Planning Commission Regular Meeting

BGV Parcel 6 Second
Resubdivision Plat

Subject:	Final Hearing for the Valor Heritage Subdivision (BGV Parcel 6) (Class A Subdivision Final Hearing, PL-2025-0148)
Proposal:	The applicant proposes to create a new subdivision of 14 single-family lots and associated easements off an extension of Timber Trail Road by replatting Parcel 6 of the remainder of Tract C, Peak 8 Subdivision. The approved April 9, 2024 Development Agreement between the Town and BGV and amended Peak 7 & 8 Master Plans contemplated the eventual subdivision of this parcel into 14 single-family residential lots.
Date:	September 12, 2025 (for meeting of September 16, 2025)
Project Manager:	Sarah Crump, AICP, Senior Planner
Property Owner:	P8E SFL, LLC
Applicant:	Graham Frank, P8E SFL, LLC (Breckenridge Grand Vacations)
Legal Description:	Parcel 6 Peak 8 Subdivision Filing No. 1 Proposed: Lots 1-14, Valor Heritage Subdivision
Site Area:	Total: 13.35 acres
Land Use District:	LUD 1 (allows 1 residential unit per 10 acres) Parcel 6 is subject to the Peak 7 and 8 Master Plan which supersedes the Land Use Guidelines regarding use and density and allows for 14 Single-Family Equivalents

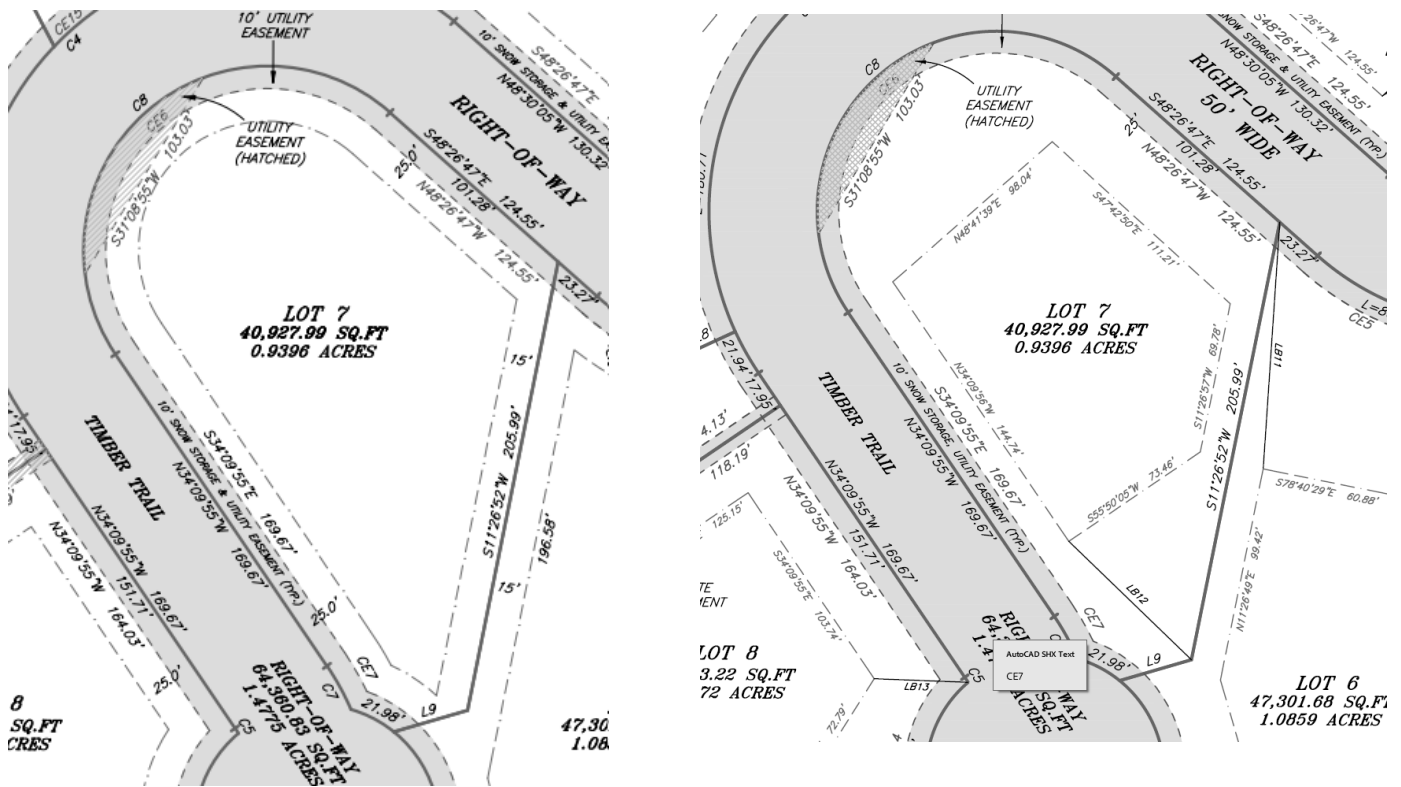
The applicant has revised each lot's disturbance envelope and made substantial modifications to the location, size, and/or shape of each. The applicant also provided information on the adjacent subdivisions, Timber Trail Filings 1 and 2, and the percentage of lot coverage that the existing disturbance envelopes include in those subdivisions. This information was further verified by staff. Barring one outlier lot of 18 percent, Timber Trail Filings 1 and 2 disturbance envelopes range in size from 5,486 square feet to 16,864 square feet and cover between 32 to 44 percent of the lots. The Valor Heritage Subdivision has, on average, slightly larger lot sizes than Timber Trail. The revised disturbance envelopes now range in size from 10,788 to 16,983 square feet and cover between 32 and 39 percent of each lot. With discretion given for the larger lot sizes, the percentage of disturbance envelope lot coverage as revised better aligns with the average disturbance envelope lot coverage of Timber Trail. Staff finds the comparison to Timber Trail Subdivision disturbance envelopes to be a valid metric, considering that the size of homes, topography, and desired programming will be similar within Valor Heritage to those of the existing Timber Trail Subdivisions. The reduced envelopes will still be large enough to accommodate the allowed 7,500 square-foot residences, with allowance for some flexibility on placement of the homes and allowance for some outdoor programming, but not so large that they effectively follow the setback lines of the properties and maximize disturbance potential. The revised envelopes will provide better buffering and setbacks between residences and consider existing slope and natural tree stands. Staff appreciates the revisions and believes the revised disturbance envelopes now meet the intent of the subdivision standards.

Figure 4. Left: Lot 7 showing previous disturbance envelope following required setback line, resulting in a "disturbance" envelope that allows disturbance -- including buildings, decks, and patios -- on the vast majority of the lot. Right: Revised Lot 7 disturbance envelope is essentially halved in size and no longer extends across the majority of the lot.

SUBDIVISION PLAT
VALOR HERITAGE SUBDIVISION

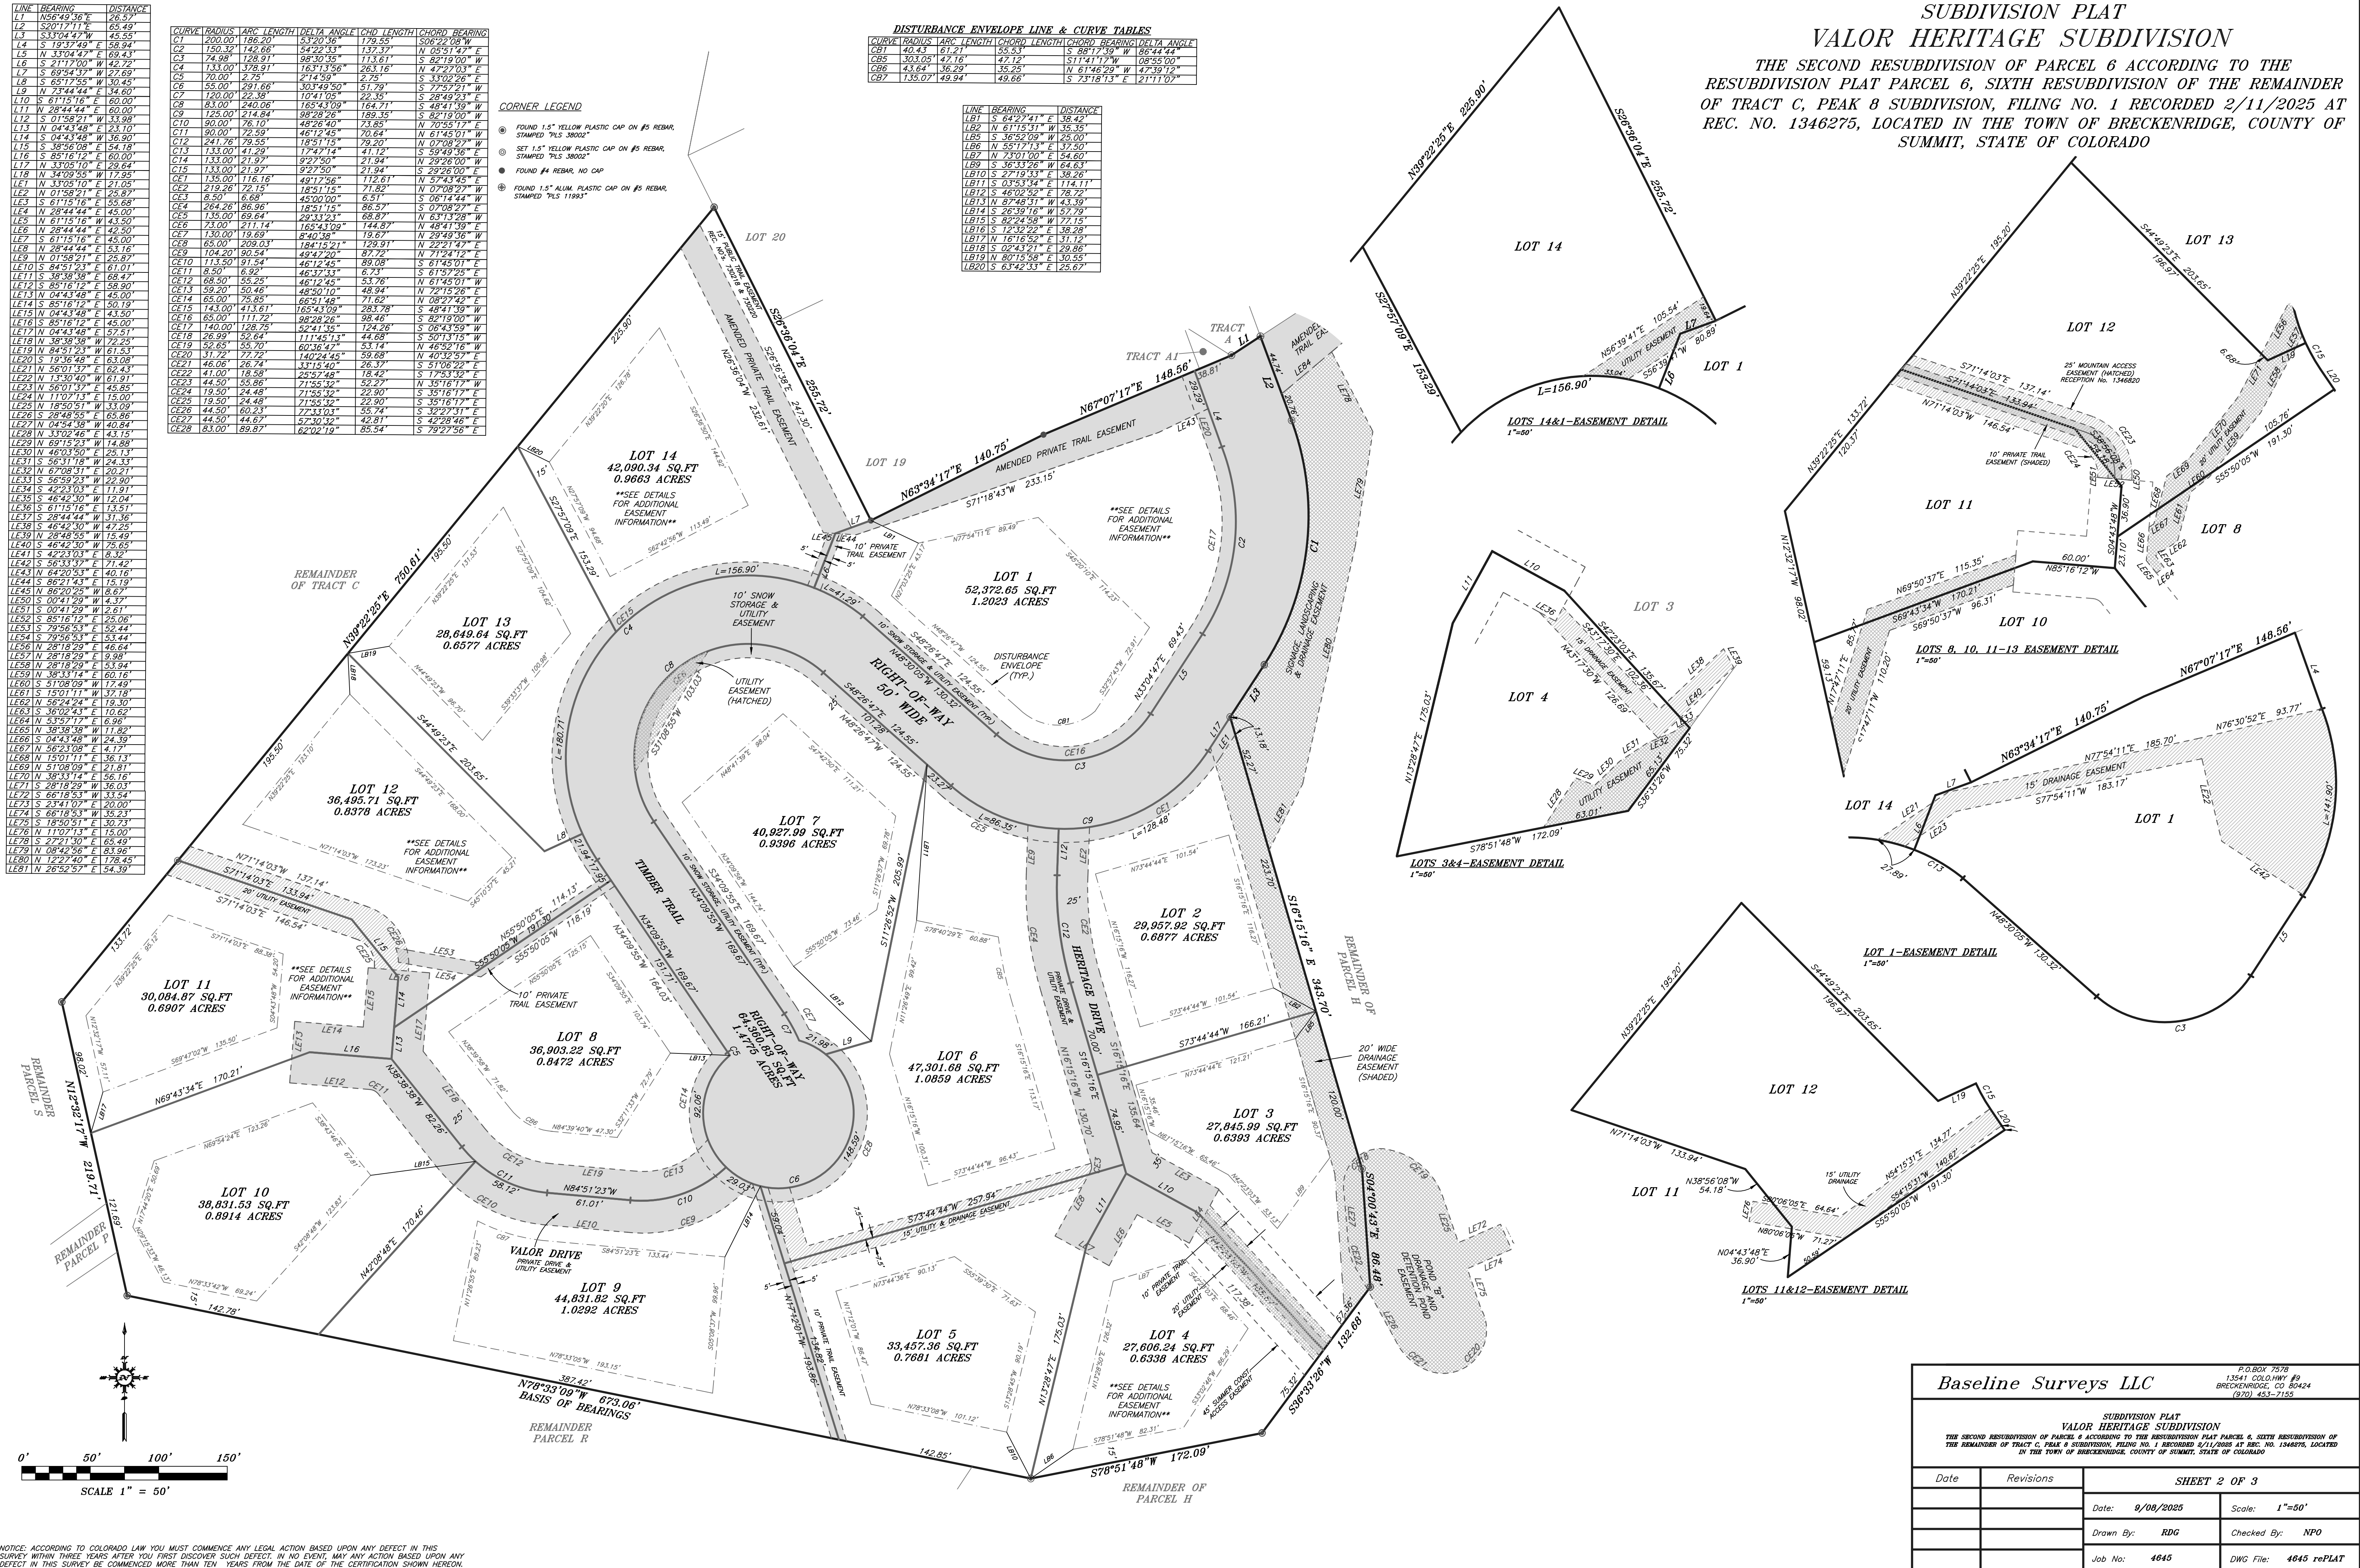
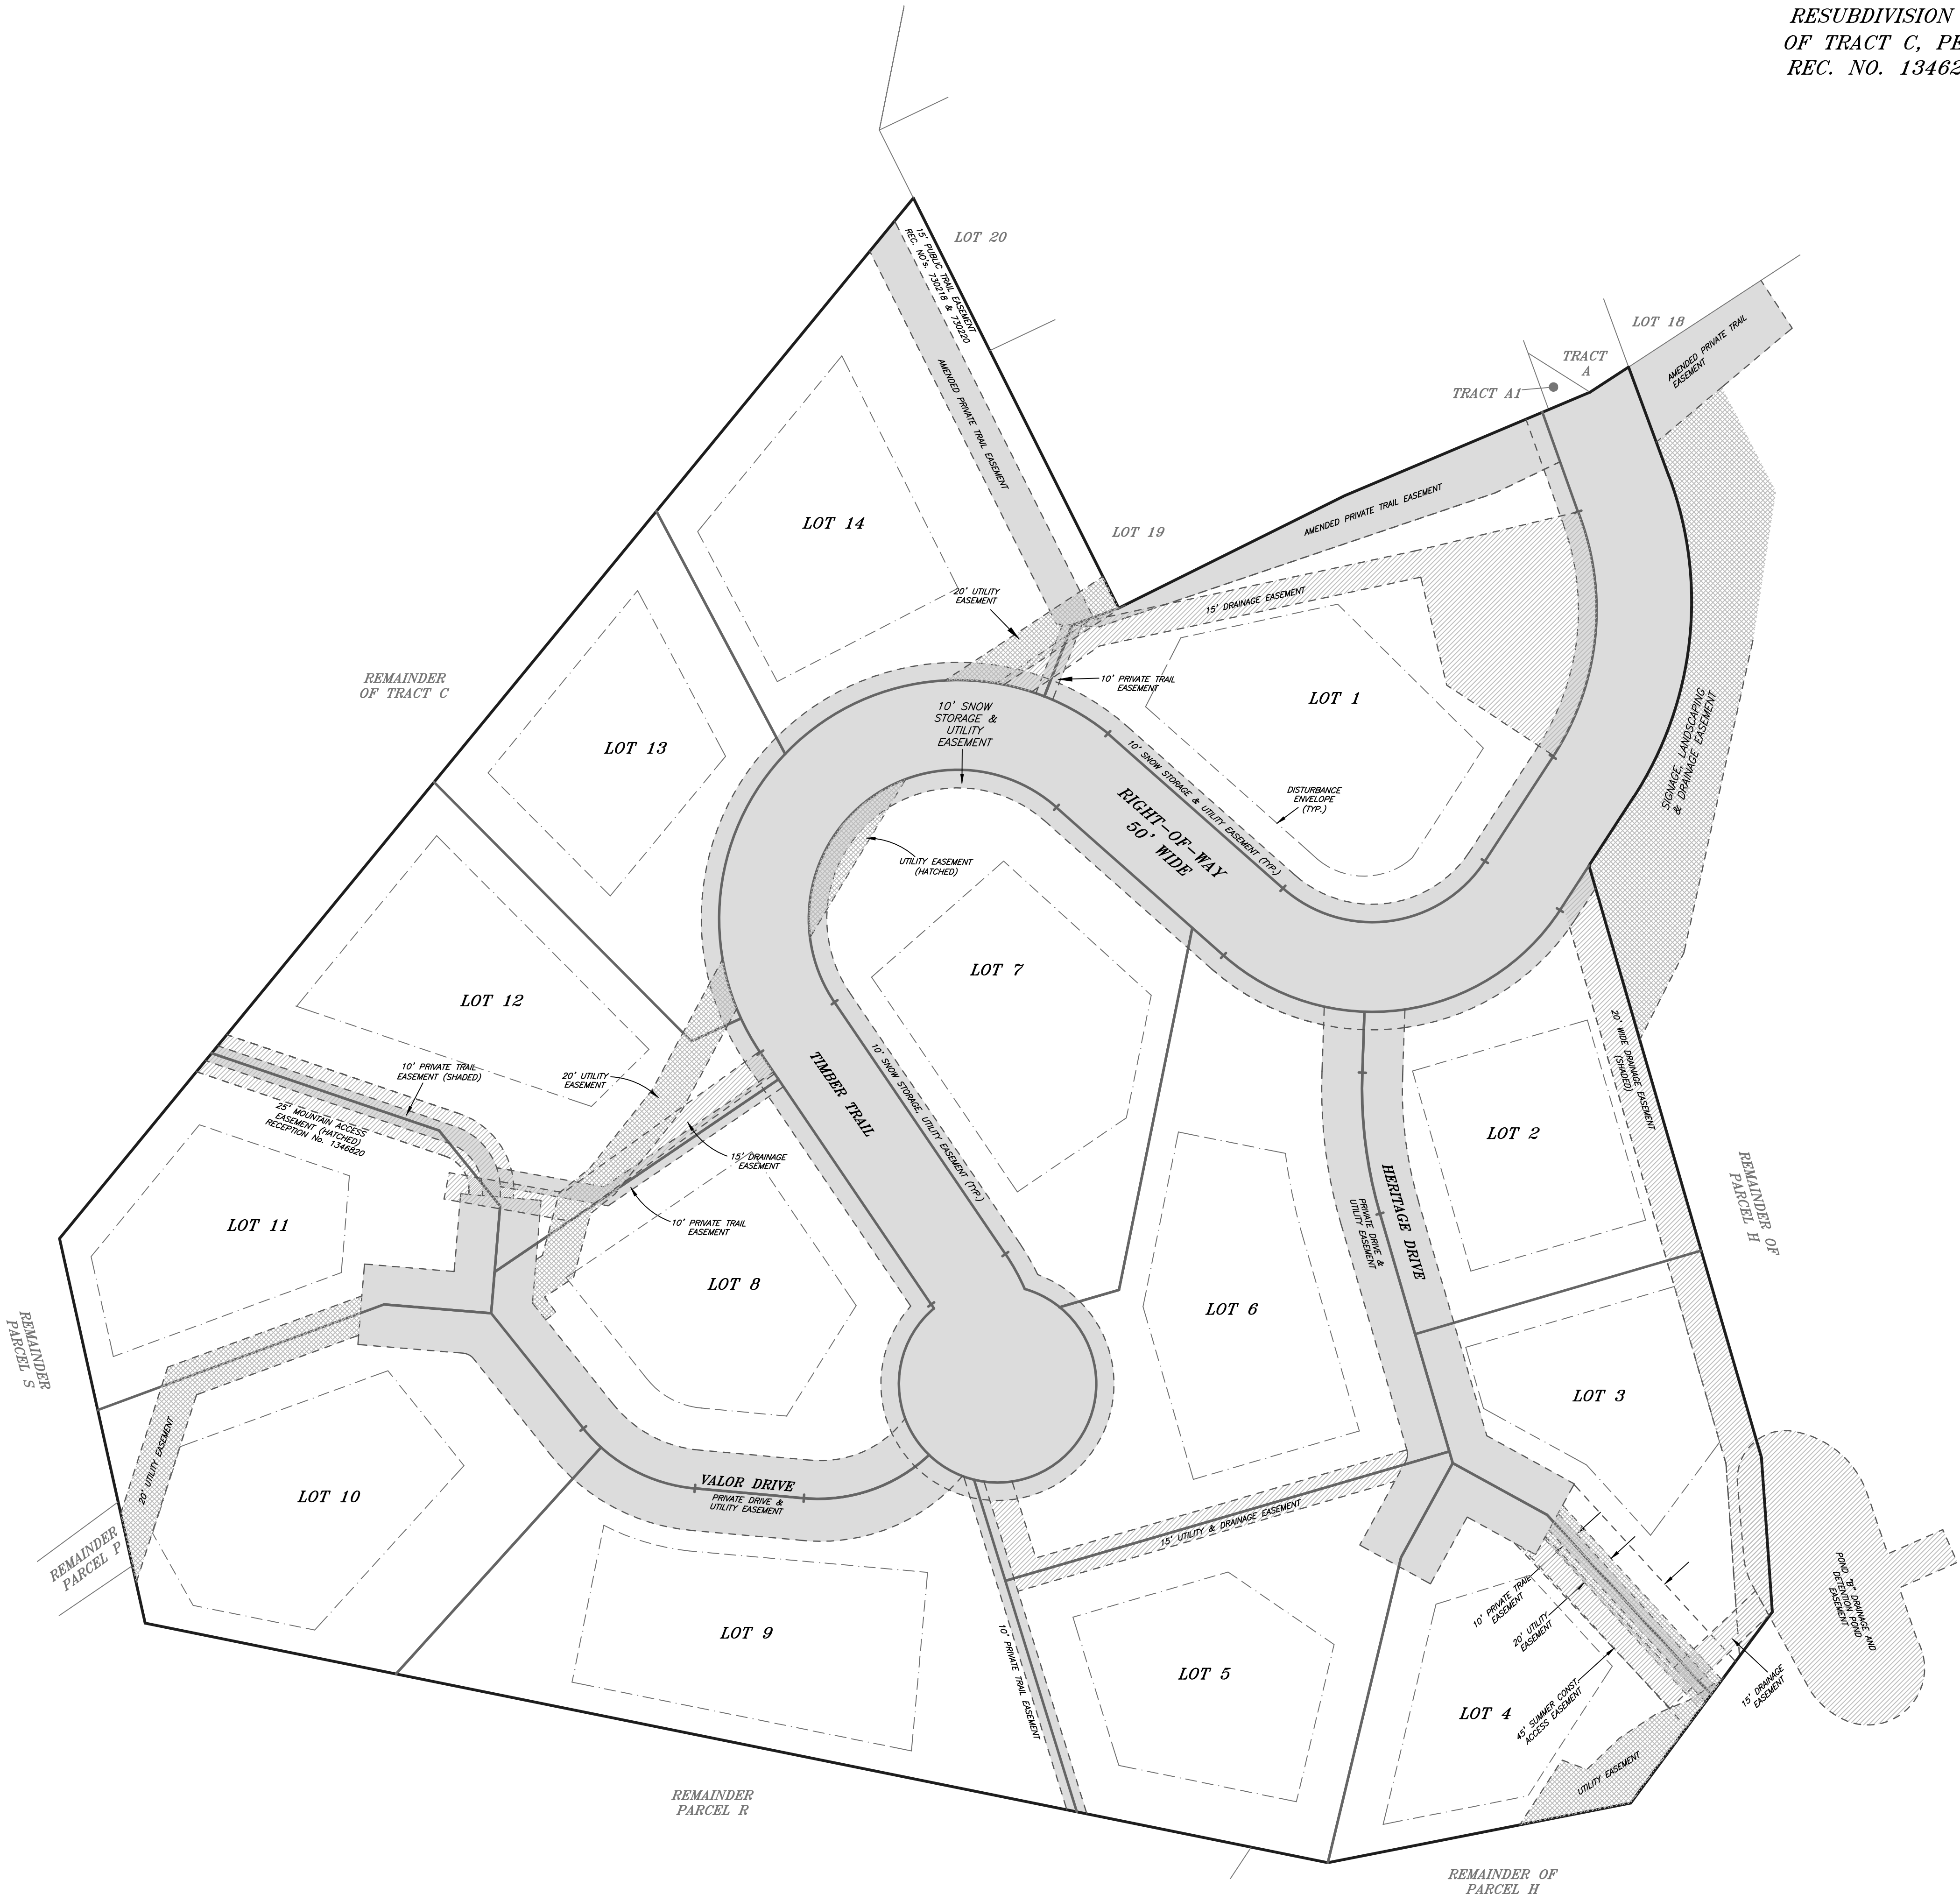
Planning and Engineering have requested that the applicant provide a revised and combined sheet 3 of the proposed plat to reflect all labels and easements shown on page 2 also on page 3. The location and function of easements will not change. A condition of approval to this effect has been added to the findings and conditions attached.

8. **Applicant shall revise sheets 2 and 3 of the plat to reflect a combined page showing all labels and easements in a form to the satisfaction of the Town's Planning and Engineering Divisions.**

2. For better readability, suggest following the many comments on the plat that would combine easements and avoid confusion where there is overlap. Overall subdivision drawing shall depict all easements. Details may be used for clarification only.

1.1. See attached redlines for required changes to the plat. The overall subdivision drawing shall depict all easements. Details may be used for clarification only.

The Parcel 6 development looks great. However, I have one minor change if possible. On the document labeled 4645_PARCEL 6 Plat Sheet 1, Item # 7 of the plat notes – can you change “Uniform Fire Code” to “International Fire Code” please? We no longer use the Uniform Codes. I attached the sheet and noted the area to change. Thanks so much for your help with this. Jackie Pike

Staff's requested revisions to the proposed plat have been made. These include deleting reference to a "resubdivision plat" in the title and "July" in the surveyor's certificate and picking-up the easement depiction comments. An overall subdivision plan showing all of the easements has been provided, easement hatching has been revised for consistency, and details have been used when there are overlapping easements to help provide clarity. In reply to Staff's plat redline questions/direction:

As noted above, the plat has been revised with an overall subdivision drawing showing all easements, hatching is now consistent, and details have been used to provide clarity in the case of overlapping easements. (Please also see our plat note comments below relating to priority of easements.) We believe the revised plat is more understandable and appreciate Staff's plat organizational suggestions.

We appreciate the fire district’s support of the project and have revised plat note 7 as requested.
